Re: Northrop Grumman Comments on Bethpage Remedial Options Report

Comments on Remedial Options Report Regarding the Bethpage Plume

**Northrop Grumman Systems Corporation
Bethpage Facility**

September 9, 2016

FIGURE
3B

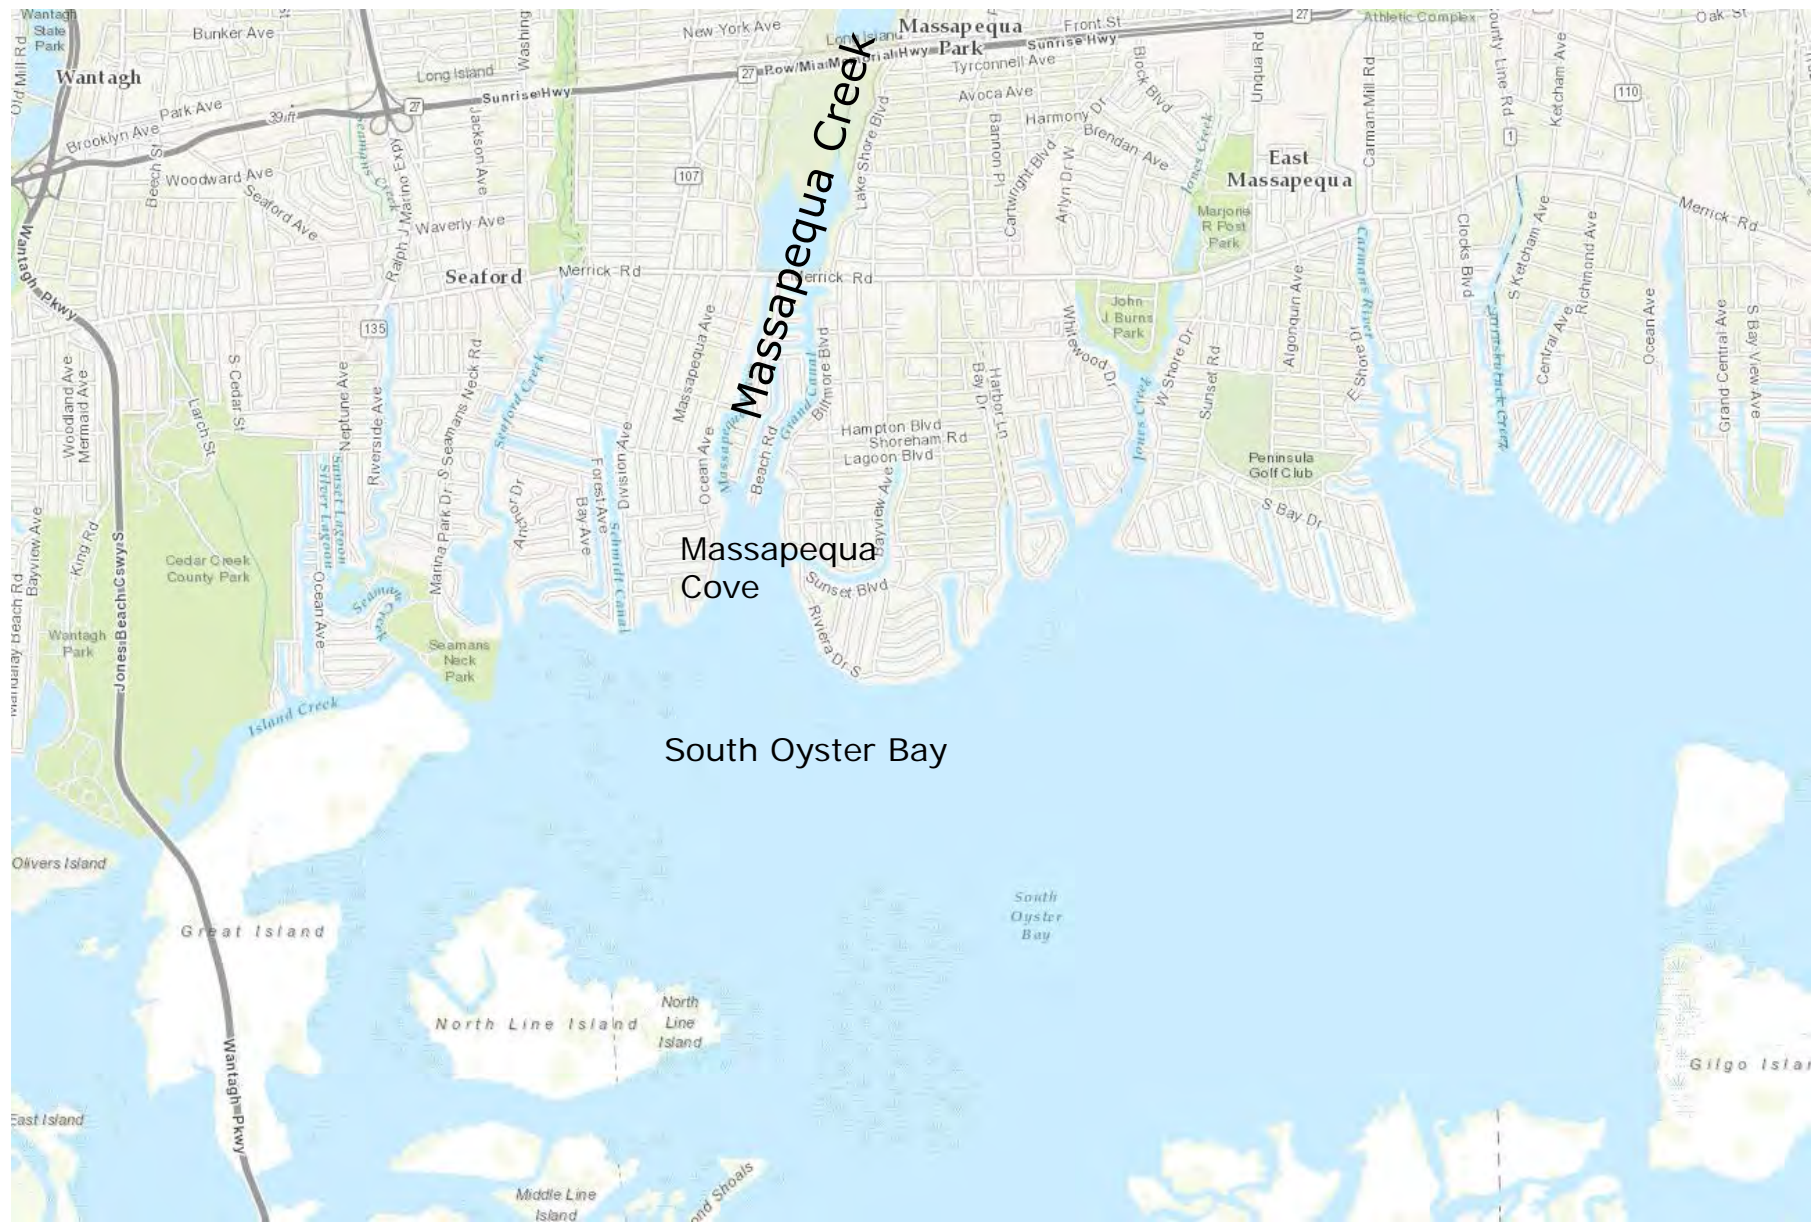
Nassau County. The creek and the associated preserve (**Figures 3A, 3B, and 3C**) provide habitat for a variety of plant and animal species. The damage from the proposed remedies would impact both the recreational qualities of the creek and preserve and the ecological benefits they provide.

FIGURE
4A

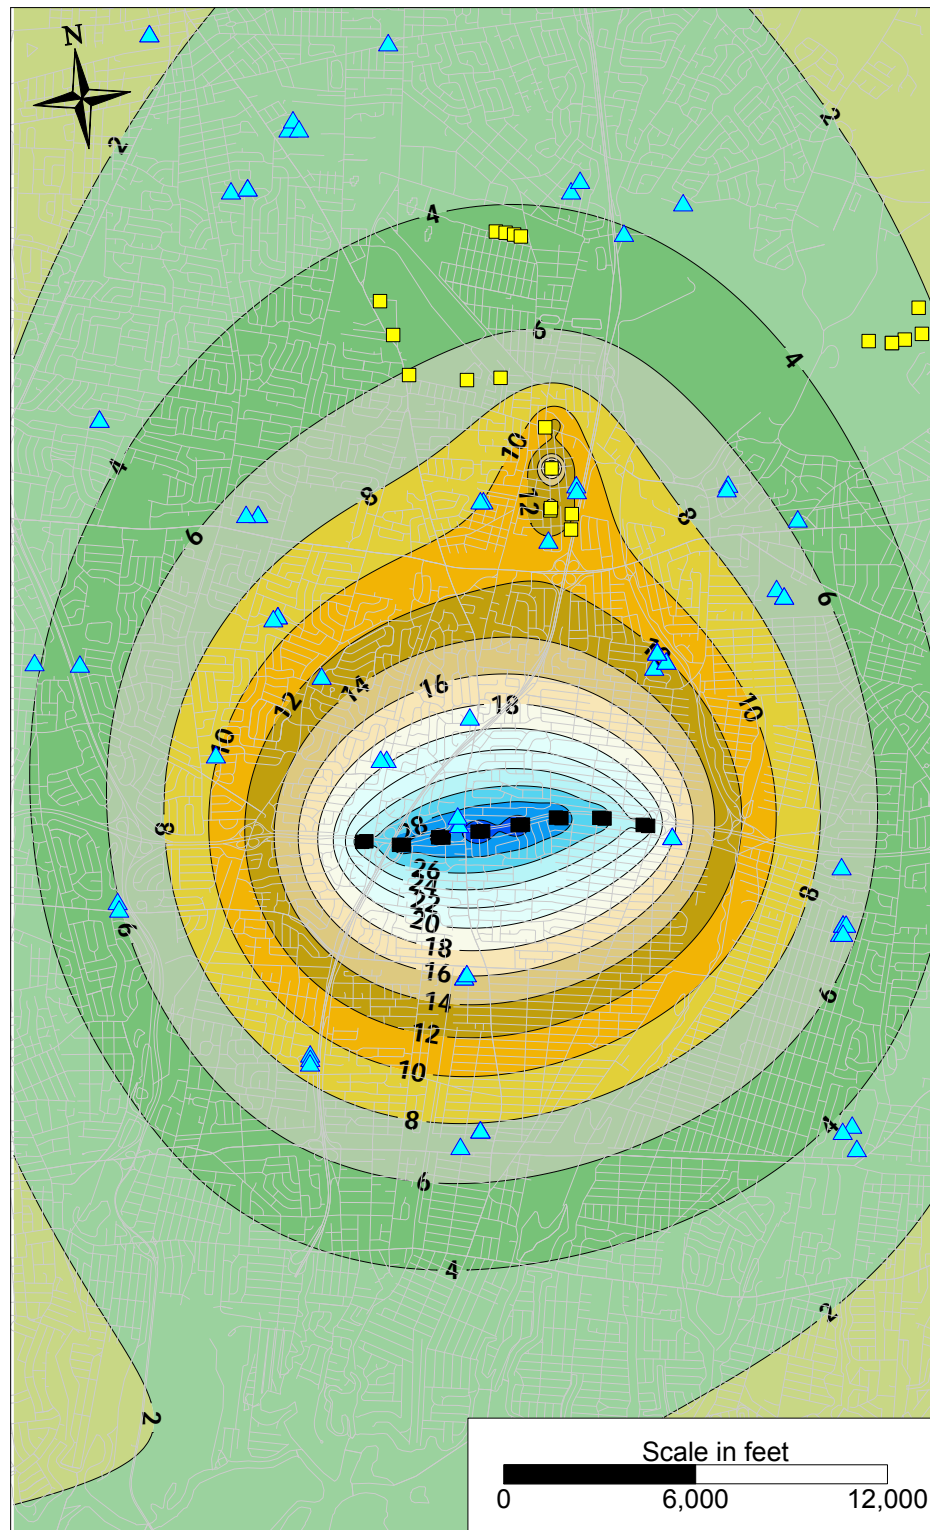
The connections among Massapequa Creek, Massapequa Cove, and South Oyster Bay are illustrated on **Figures 4A and 4B**. These figures also show the locations of seagrass beds and clam and shellfish beds in South Oyster Bay. Seagrasses in the area (particularly marine eelgrass) are the focus of New York State Seagrass Task Force because they stabilize sediments, reduce wave turbulence/storm surge, improve

SIMULATED GROUNDWATER DRAWDOWN
PRODUCED BY REMEDIAL OPTION 1

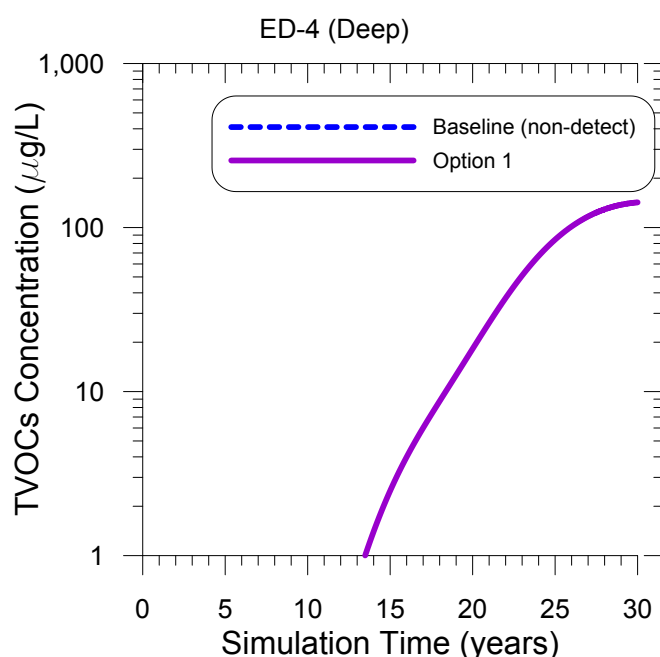
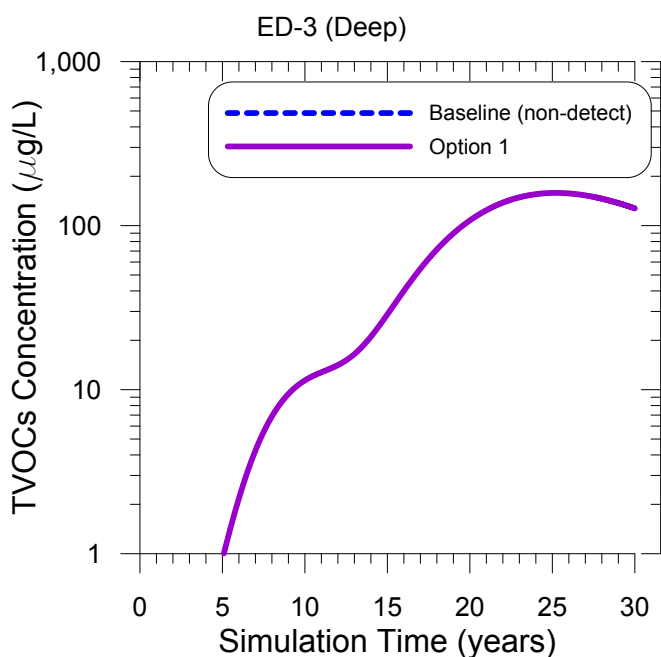
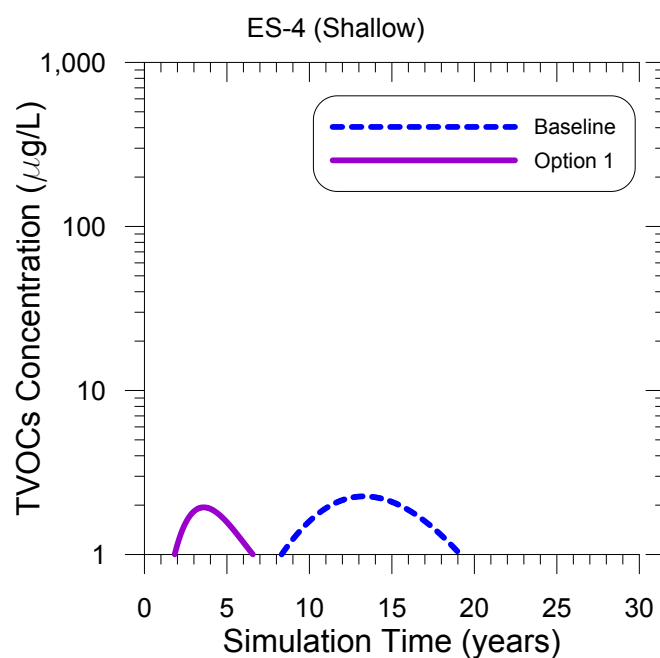
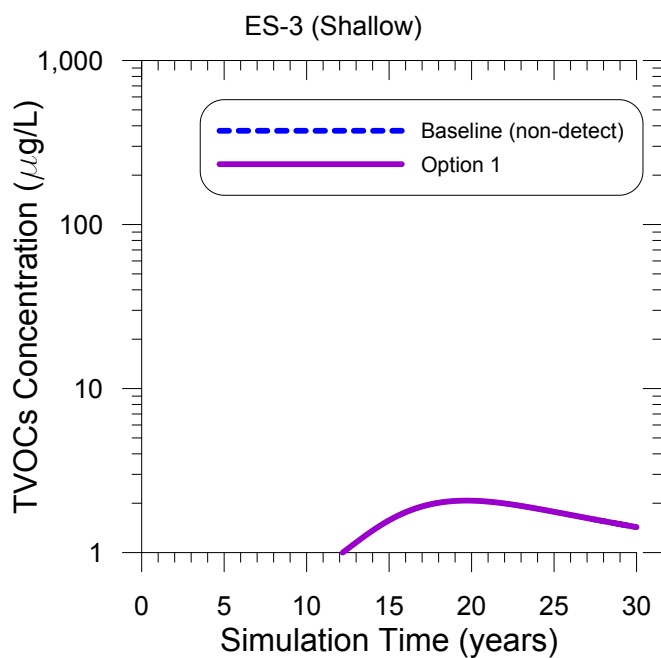
Repeatedly exceeding the sustainable yield would substantially reduce the water currently available to public supply wells, particularly those nearest the proposed extraction wells (i.e., South Farmingdale Water District Plants 4 and 6 and New York American Water Seaman’s Neck Plant). Magothy aquifer drawdown in the zone of influence of the proposed extraction wells would increase 20 feet or more near South Farmingdale Plants 4 and 6 and over 30 feet at the containment wells (**Figure 5**). This

drawdown may necessitate modifying the supply wells and pump elevations or possibly installing new wells to extract water deeper in the aquifer. These well modification options would be viable only if the quality of water at lower depths in the aquifer is not impacted by saltwater intrusion (see previous discussion of saltwater intrusion).

SIMULATED DISTRIBUTION OF VOC PLUME
UNDER BASELINE CONDITIONS AND
PRODUCED BY REMEDIAL OPTION 1
IN 30 YEARS

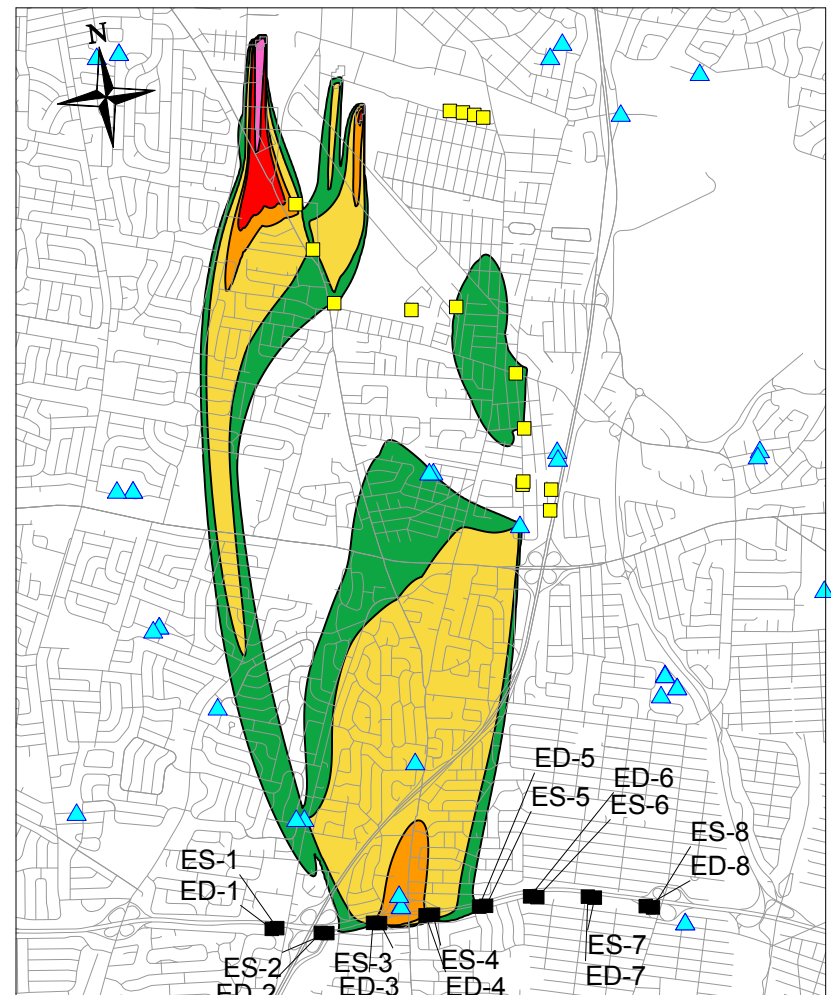
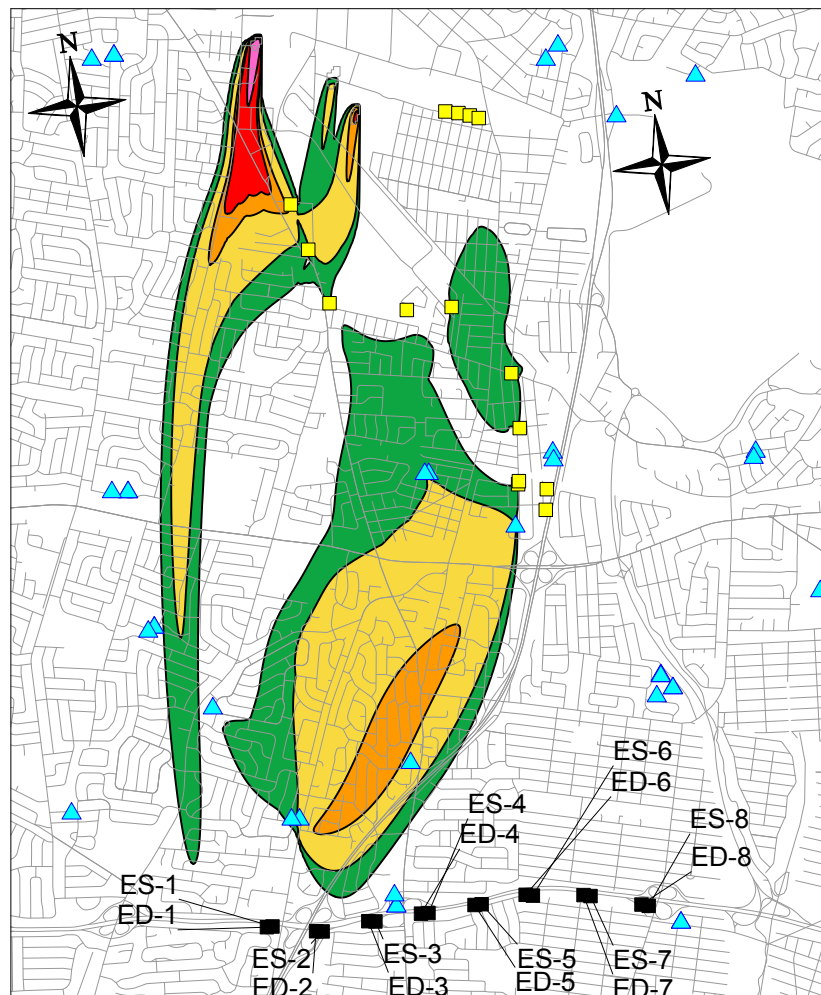
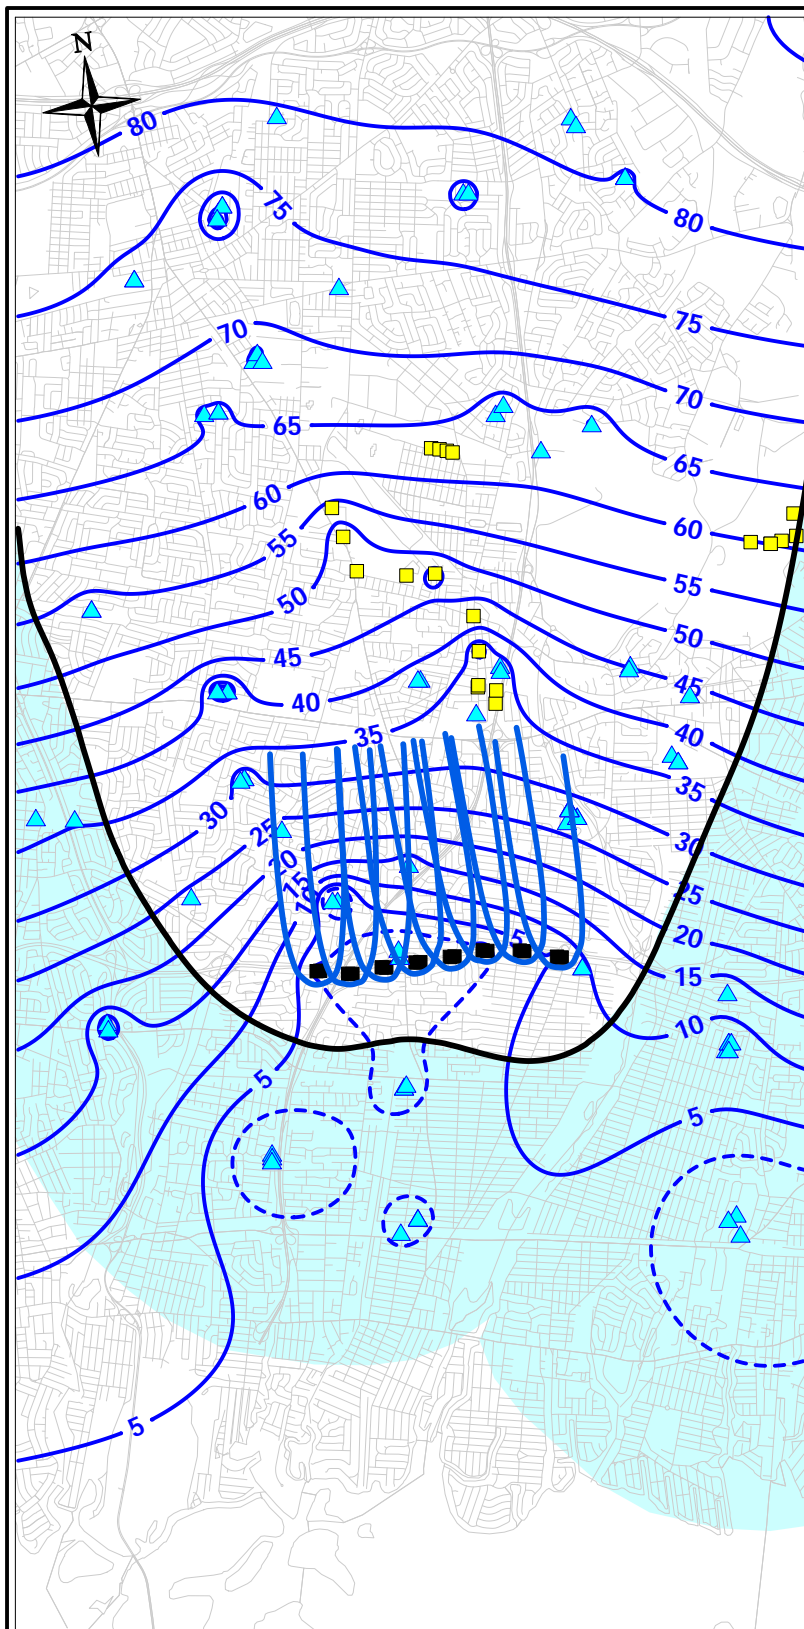
TVOC concentrations are simulated at proposed extraction well locations that would be impacted under Option 1 (see Figure 6 for well locations).
